APPENDIX D

Shawnigan Research Group (SRG) Information Submissions
May 31, June 08, June 13 & June 21, 2017

Response to MOE re Cobble Hill Holdings "As-Built" submission of April 18, 2017

Review - SHA Final Closure Plan

Fig 5

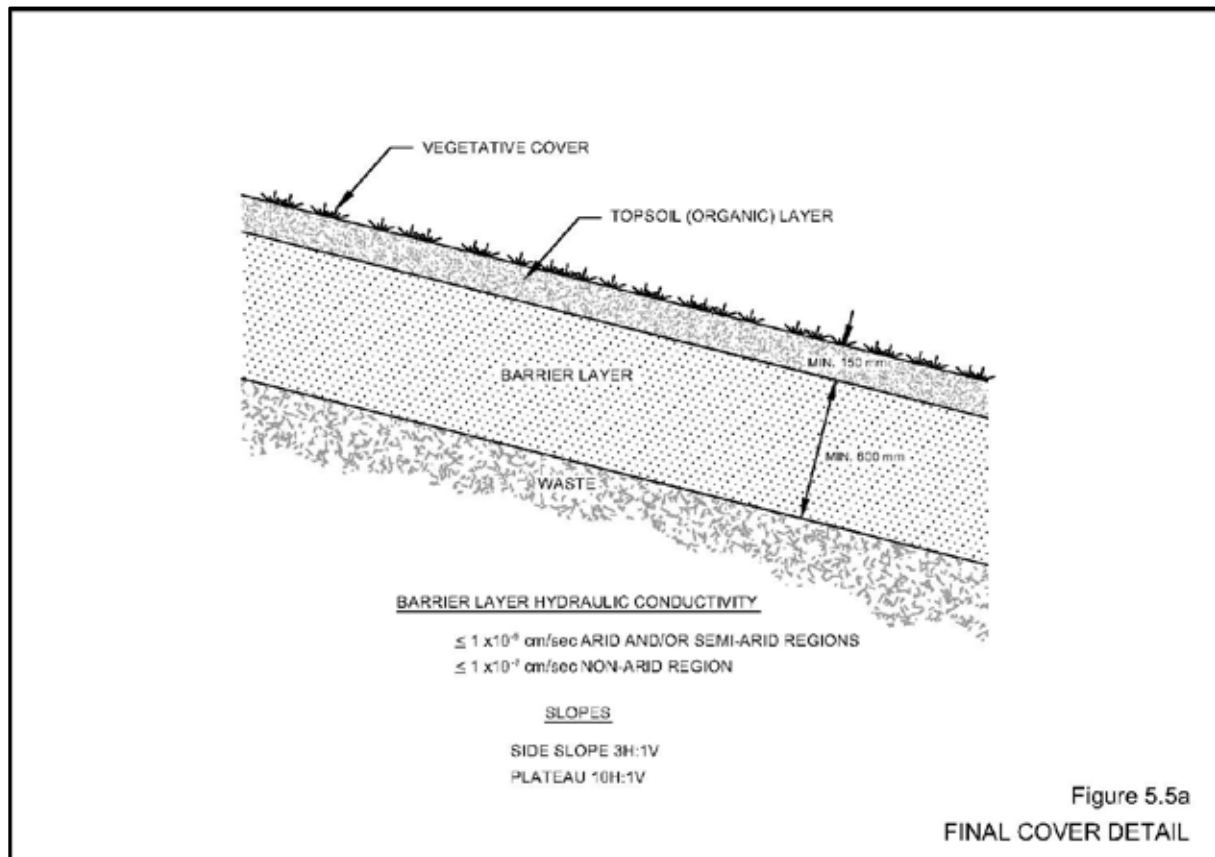
The map from the companies, Fig 1 above, claims that the slope on the upper left, the northwest facing slope, is 3H:1V, and that the slope to the upper right, the northeast facing slope, is 2.5H:1V. In fact, neither slope meets the requirement for final contours.

Fig 6

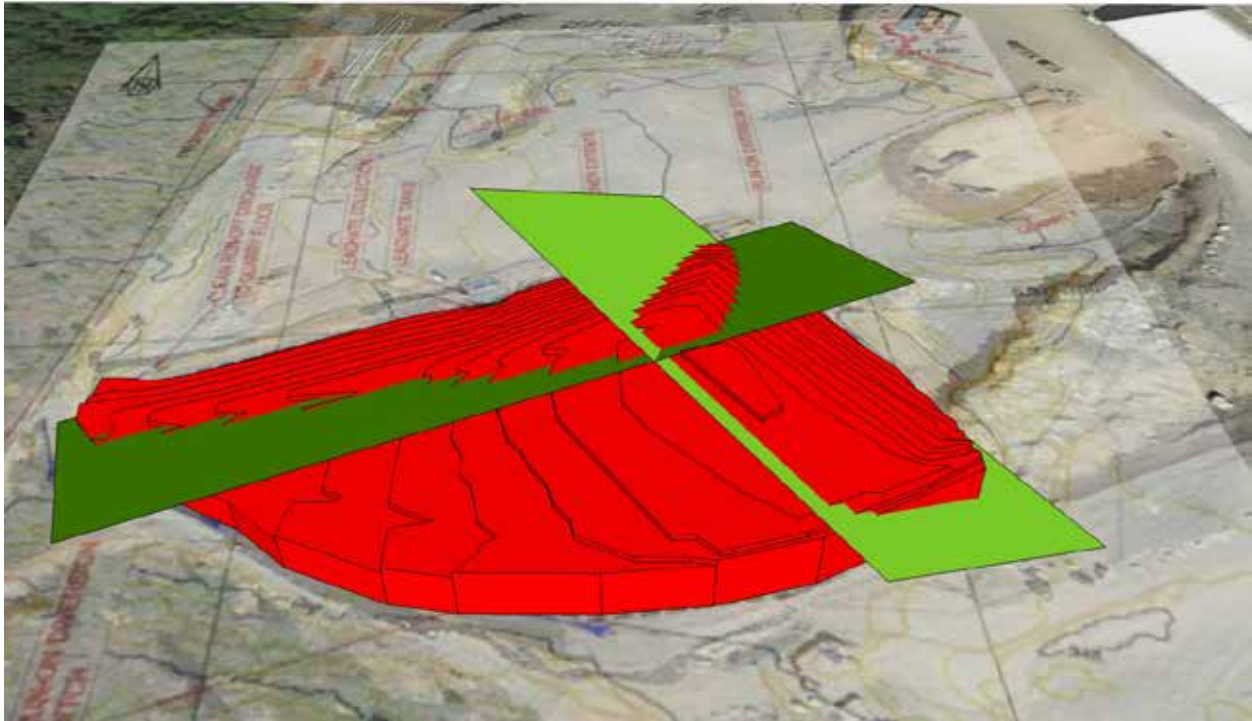
This Sketchup model was adapted from Fig 4 by the addition of a plain with slope 3H:1V through the NW face (dark green), and a second plain with slope 3H:1V through the NE face (pale green). All the waste above the plains must be removed for the waste pile to conform the LCMSW.

Fig 7

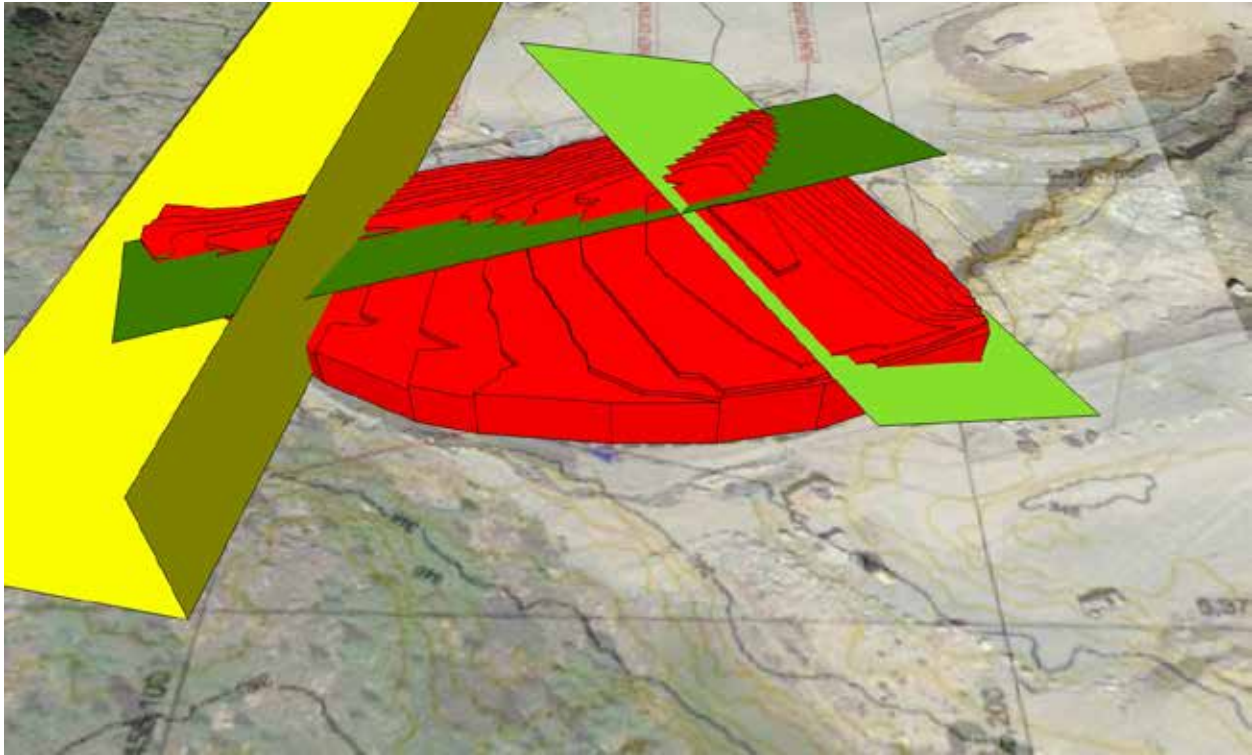
Section 3.4 of the LCMSW requires that the "buffer zone between the landfill footprint and the landfill site boundary shall be a minimum of 50 m."

In Fig 7, a yellow buffer 50 m wide with a vertical face has been added. Of course, the face cannot be vertical. Rather, it must satisfy the 3H:1V rule.

Fig 8

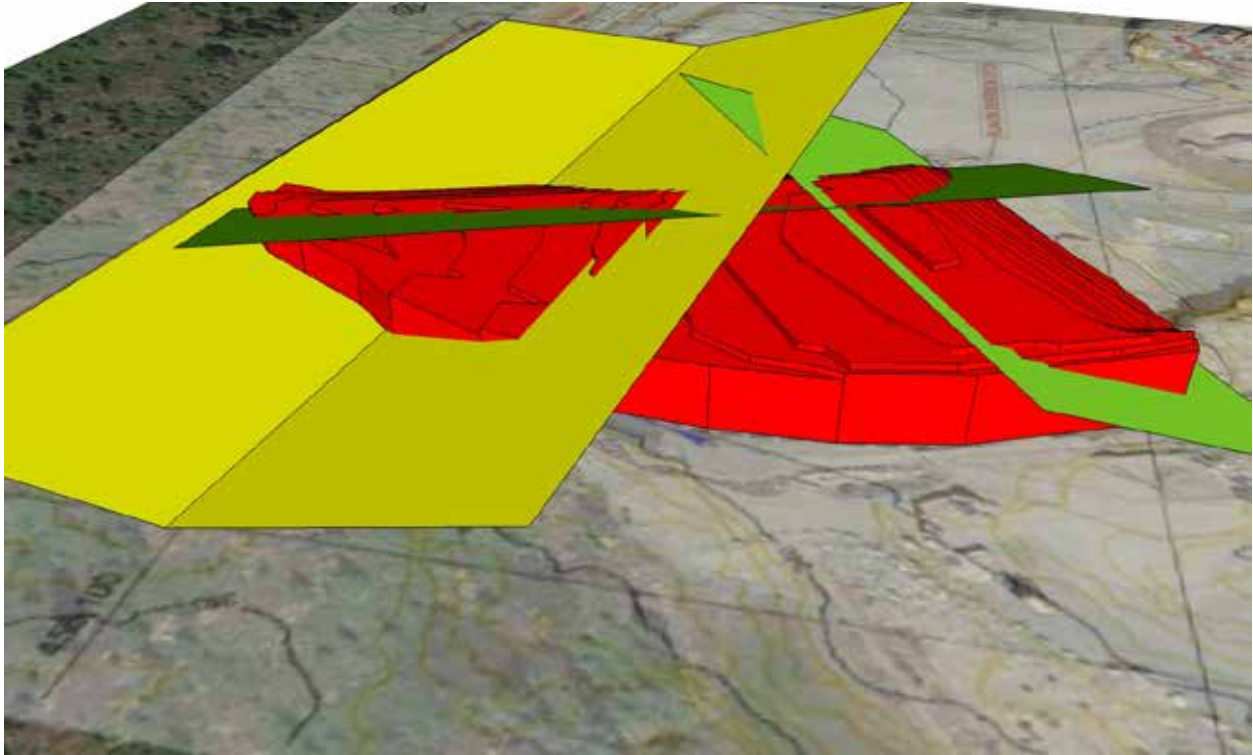
Here the new west face of the waste pile is shown. Allowing for the 50 m buffer zone and the 3H:1V slope of the new west face, all the current waste above the yellow face must be removed in order for the remaining waste to meet the LCMSW standard.

Fig 9

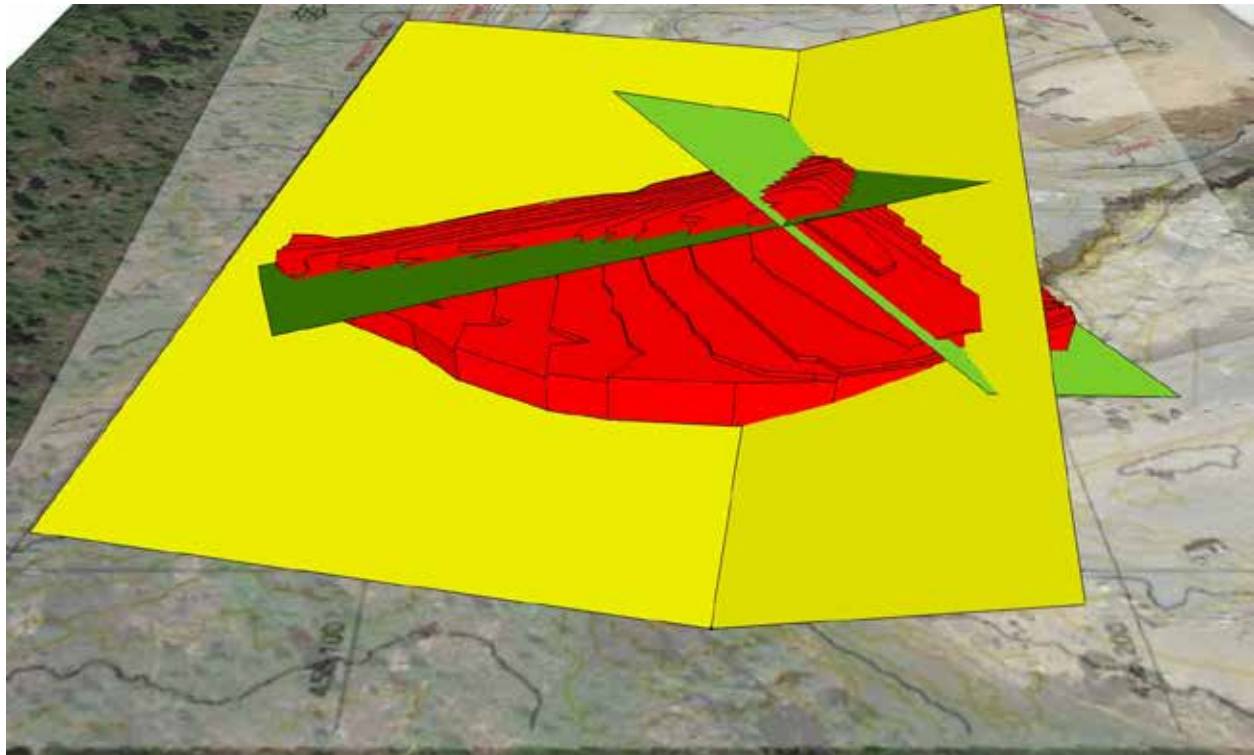
The land to the west of the contaminated waste landfill is a regional park. That is, it is a park owned by the regional district.

Section 3.8 of the LCMSW, ENVIRONMENTALLY SENSITIVE AREAS, requires of buffer of 100 m of this regional park.

Fig 11

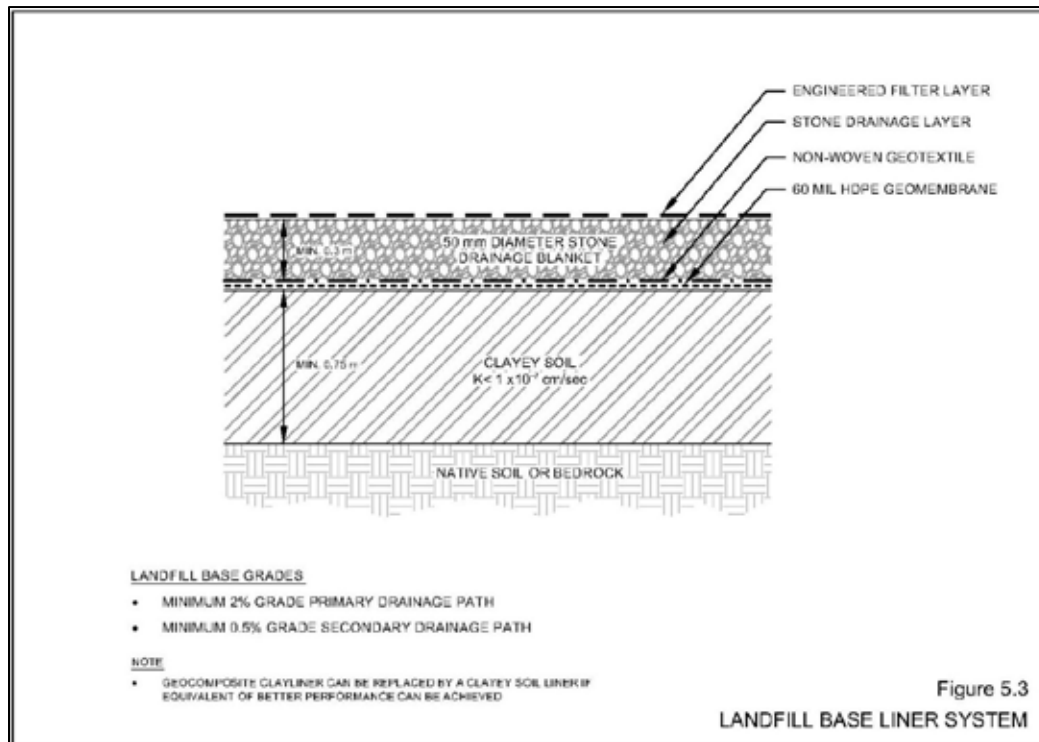
Their own report, the [Landfill Closure Plan](#), Section 3.2, specifies a 60 mil base liner once the waste in this temporary location is moved to its permanent location. Indeed, that document acknowledges the need to fully comply with Section 5.4 of the LCMSW.

Fig 11 shows the full specification for the "Landfill Base Liner System", as found in Figure 5.3 of the LCMSW. This site lacks the non-woven geotextile above the 60 mil base liner. It also lacks the 50 mm diameter stone drainage blanket layer.

IMAGE 6: Note the base liner fold and an apparent gouge possibly formed by excavator track – see IMAGES 5 & 6.

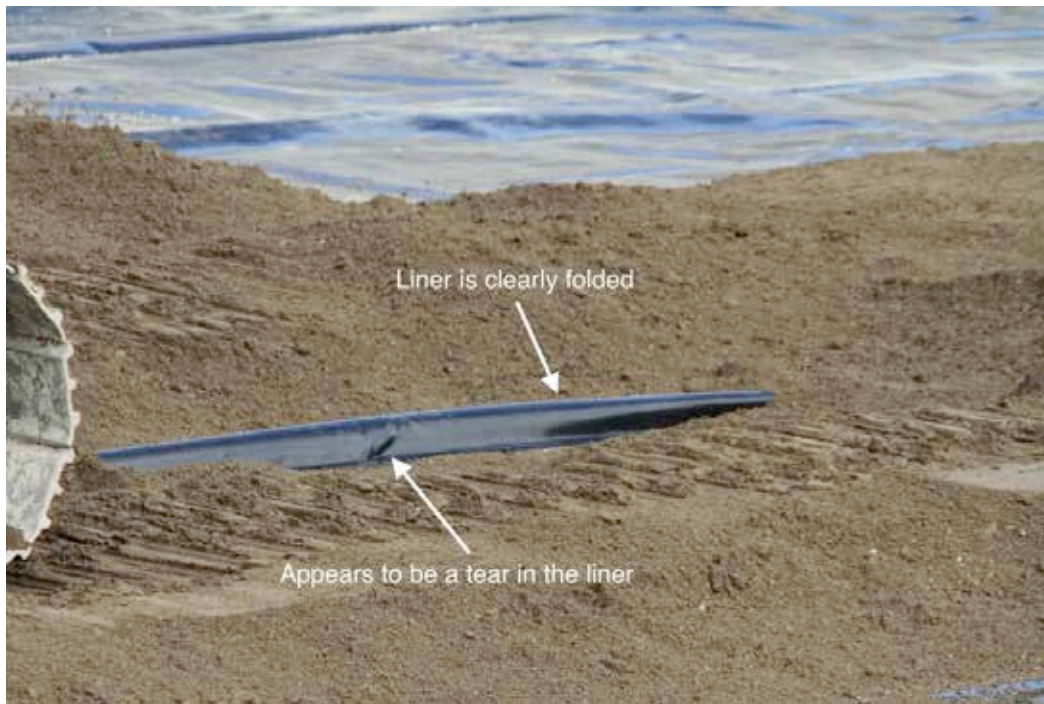
IMAGE 5: Because of moisture problems there was difficulty in welding the base liner of PEA 1C with the base liner of PEA 1B. Note the very moist contaminated soil that had to be scooped off the base liner and thrown against the wall of PEA 1B.

IMAGE 7: Excavator track marks on base liner of PEA 1C.

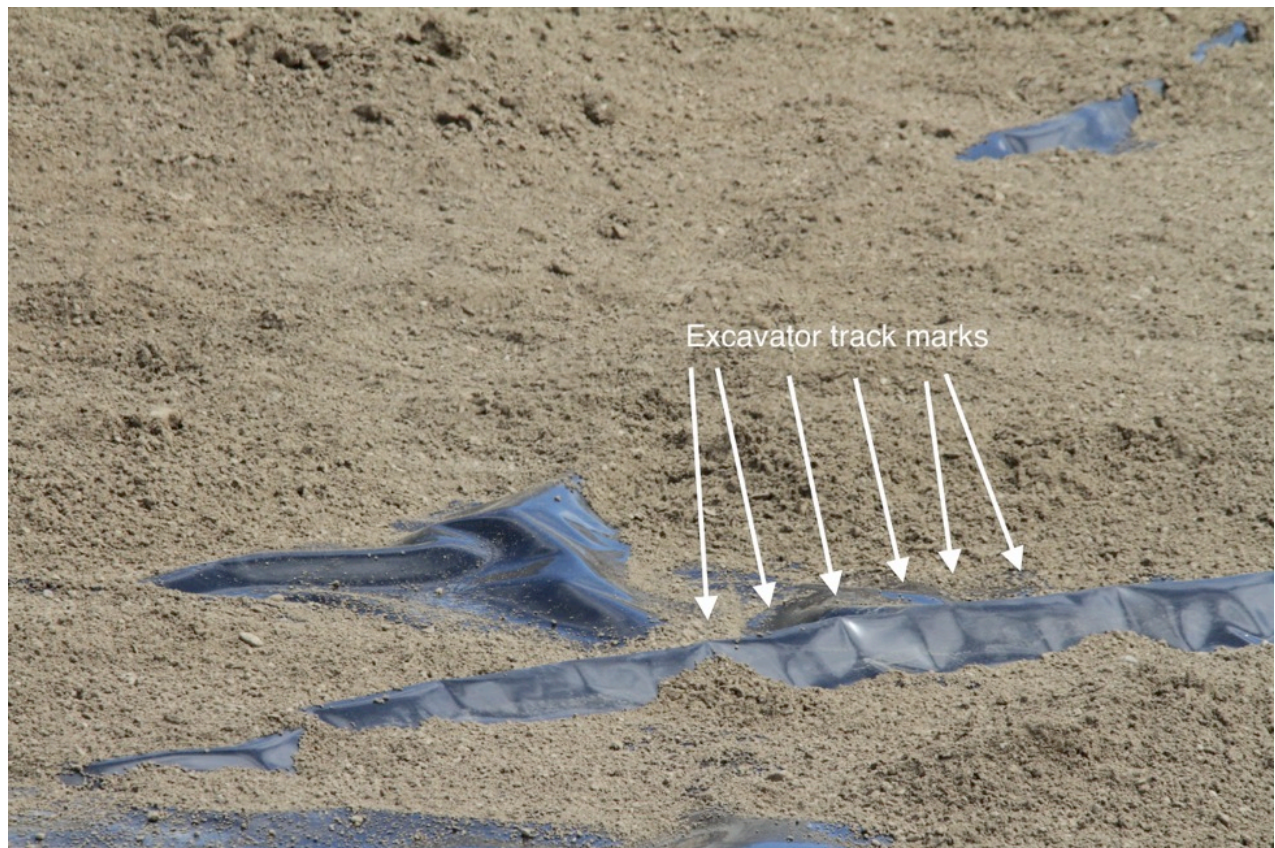
IMAGE 8: Note how close this excavator track is to the base liner of PEA 1C.

IMAGE 11: The so-called “leak detection system” designed by SIRM. The leaks would have to go **uphill** through sand and coarse crushed rock to enter the leak detection pipe. The simplest route for leaks is to flow through the

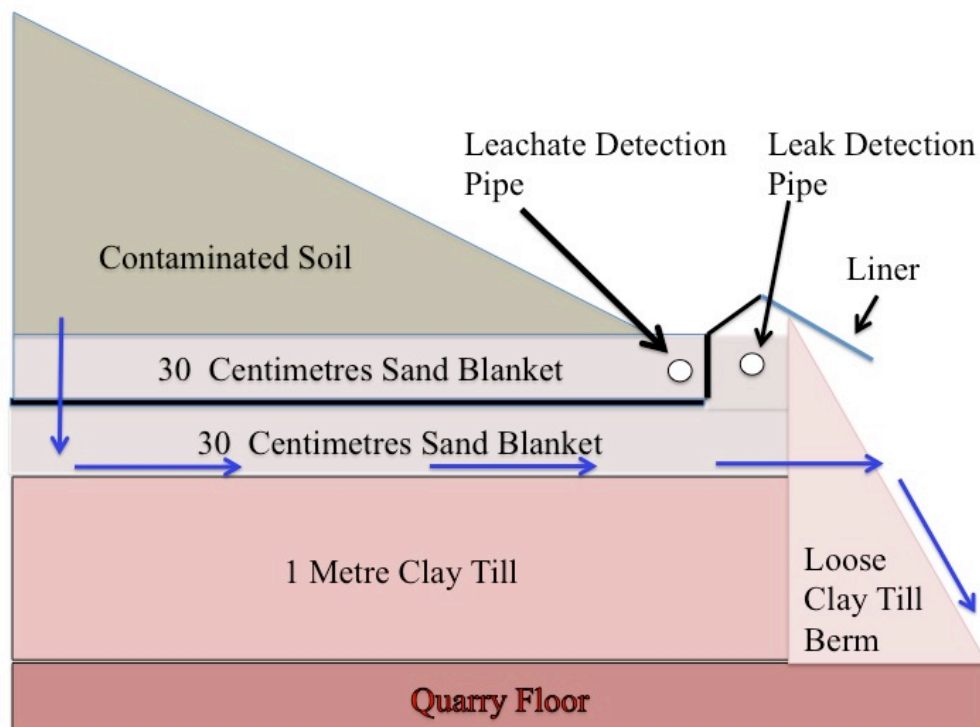
sand blanket below the liner and through the loose clay till berm and from there the leak makes its way ultimately to the Ephemeral Stream. This is the source of the wet patches seen in IMAGE 4.

Figure 5.1 shows the buffer zones required for a landfill.

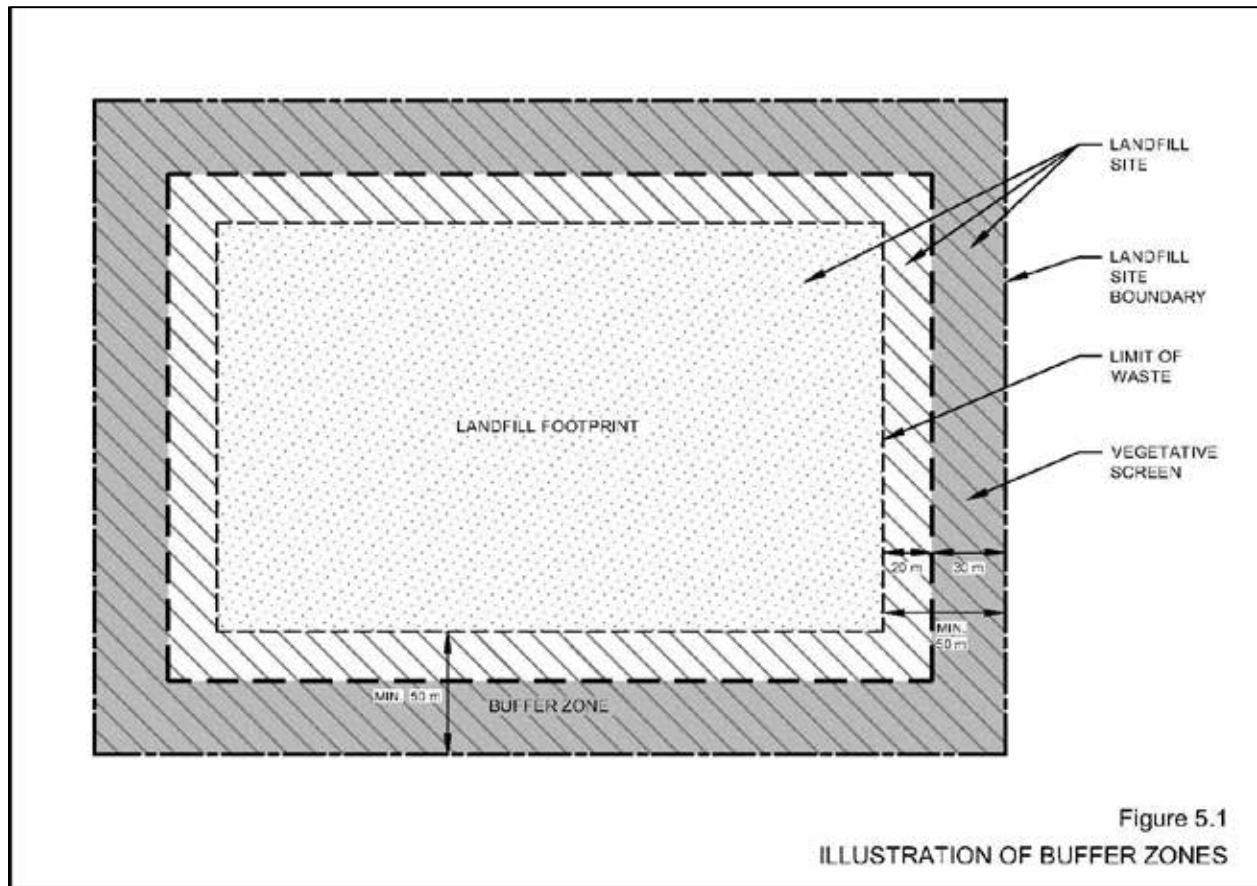
No specific mention of any of these buffer zones in DOX.

2.3.1 CLAYEY SOIL

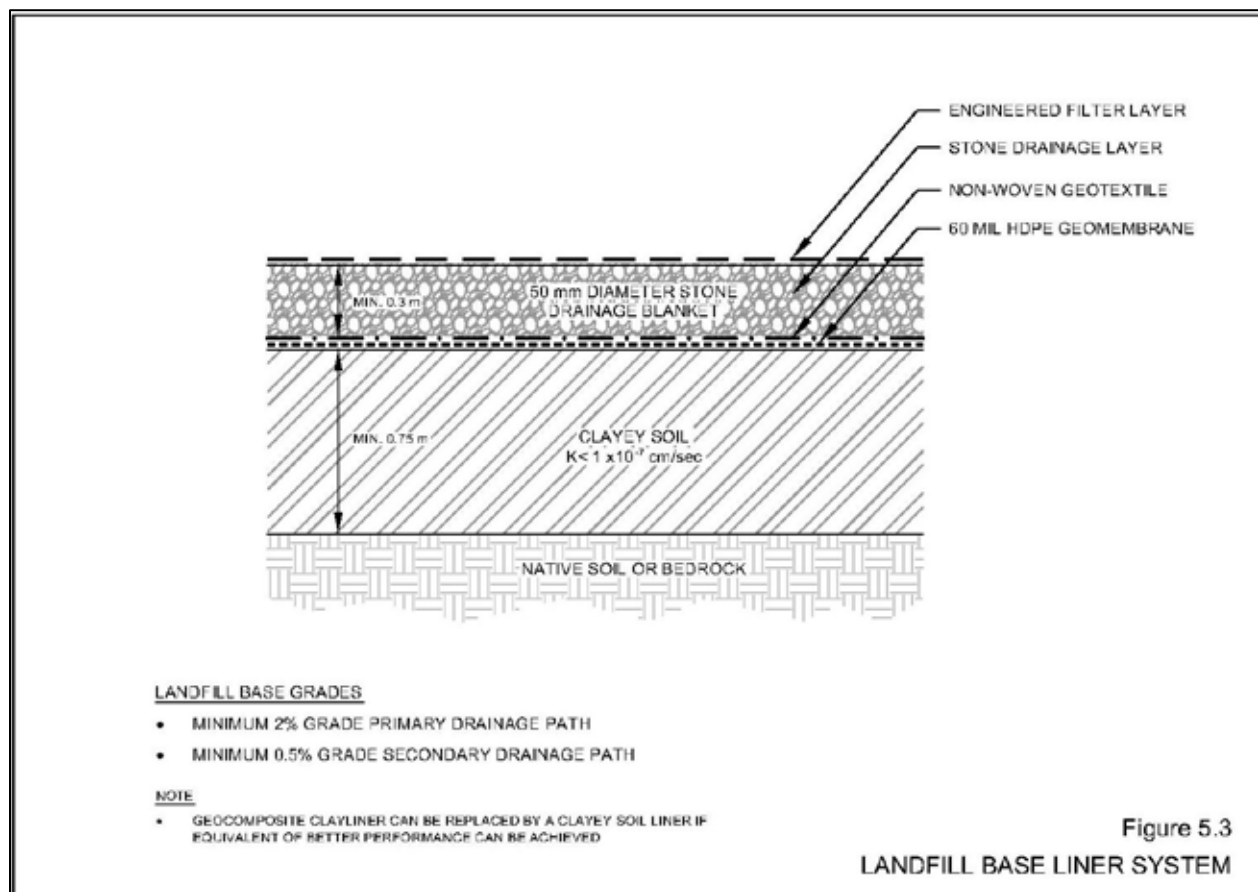
The DOX has several documents which discuss the bottom layer - the "CLAYEY SOIL". The description is scattered throughout the package, with documents discussing the three separate stages - areas 1A, 1B, and 1C.

The documentation for 1A includes detailed testing (The Levelton tests), which is not provided for area 1B or 1C. The latter two were visually inspected, found wanting, re-inspected, again found wanting, then in the case of area 1C passed based on communications from a principal of the company and an employee of the company.
